## Kerry County Council's Response to Edward Fahy Submission

Kerry County Council (KCC) would like to acknowledge the comprehensive presentation prepared by Edward Fahy.

**Figure 5.7: Bend Out Crossing (minor road AADT <4,000)**

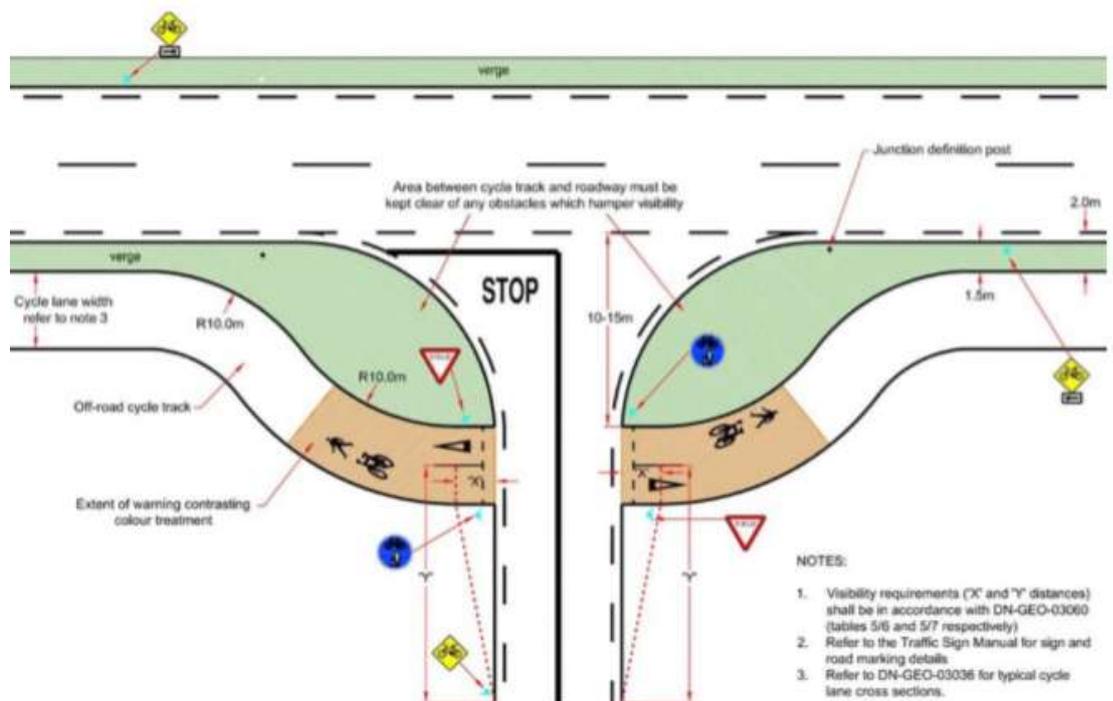
Reference 2.18 - Local Road L-7521-29 Intersection with the N70

Response: An on-site assessment was undertaken at this location. An additional on-site traffic survey on the local road at the junction recorded the 85<sup>th</sup>% speed as 14km/h and ADT (Average Daily Traffic) is very low at 81. The appropriate visibility envelope is provided to the Local Road L-7521-29 considering its proximity to the N70. The achievable visibility splay is 2.0m x 19.5m, 19.5m to the left (N70) and 100m, 100m to the right (local road L7521-29). A Bend Out Crossings is appropriate as per Figure 5.7 DN-GEO-03060 Geometric Design of Junctions, refer to figure below. The greenway design speed is 10km/h, reduced radii, chicanes and warning signage are provided at the junction. The greenway alignment is designed to slow users on approach to the junction. The greenway crosses a public road and therefore 2 splays are measured. Additional warning signage at the N70 junction is also provided, refer to drawing 318-121 RevA.
